Access Compliance Report

Public Rights-of-Way

Intersection ID: 50942	Main Street: CEDAR_WALK_LN	Cross Street: DUNAVERTY_PL	Location: NW
ADA ID: C3608DEC1147	Ramp Type: PerpDiag	Initial Pass/Fail: Fail	Overall Compliance: No
Severity Score: 18.75			
Codes/Mitigation Info/Possible Solution		Field Measurements/Component Compliance

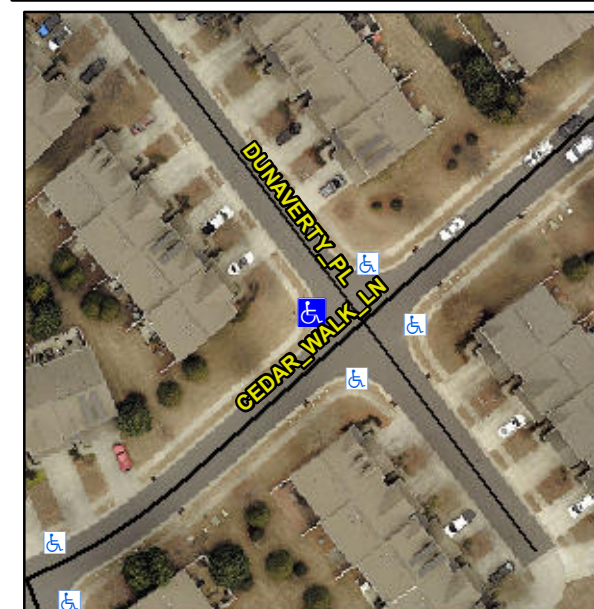
Not Found, R304.5.1, R304.5.3

Compliance	Description	Data	Compliance	Description	Data
N/A	Ramp Length (in)	94.0	Yes	Ramp Slope (%)	6.7
No	Ramp Width (in)	34.0	No	Ramp XSlope (%)	2.3
N/A	Flare Type LT	N/A	N/A	Flare Type RT	N/A
N/A	Flare Slope LT (%)	N/A	N/A	Flare Slope RT (%)	N/A
N/A	Flare Traversable LT?	N/A	N/A	Flare Traversable RT?	N/A
N/A	Landing Length (in)	N/A	N/A	DWS Provided?	N/A
N/A	Landing Width (in)	N/A	N/A	DWS Contrast?	N/A
N/A	Landing Slope (%)	N/A	N/A	DWS Length (in)	N/A
N/A	Landing X Slope (%)	N/A	N/A	DWS Full Width?	N/A
N/A	Landing Curb? (Y/N)	N/A	N/A	DWS Offset (in)	N/A
N/A	Shared Landing?	N/A			
N/A	Gutter Ponding?	N/A	N/A	Gutter Slope (%)	N/A
N/A	Gutter Lip Ht (in)	N/A	N/A	Gutter X Slope (%)	N/A
N/A	Painted X Walk1?	No	N/A	Painted X Walk2?	No
	X Walk 1 Direction	To SE		X Walk 2 Direction	To NE
N/A	X Walk 1 Width (in)	N/A	N/A	X Walk 2 Width (in)	N/A
	X Walk 1 Slope (%)	0.9		X Walk 2 Slope (%)	0.8
	X Walk 1 X Slope (%)	1.4		X Walk 2 X Slope (%)	2.3

Remove & Replace Curb Ramp With Two New Directional Ramps or Equivalent.
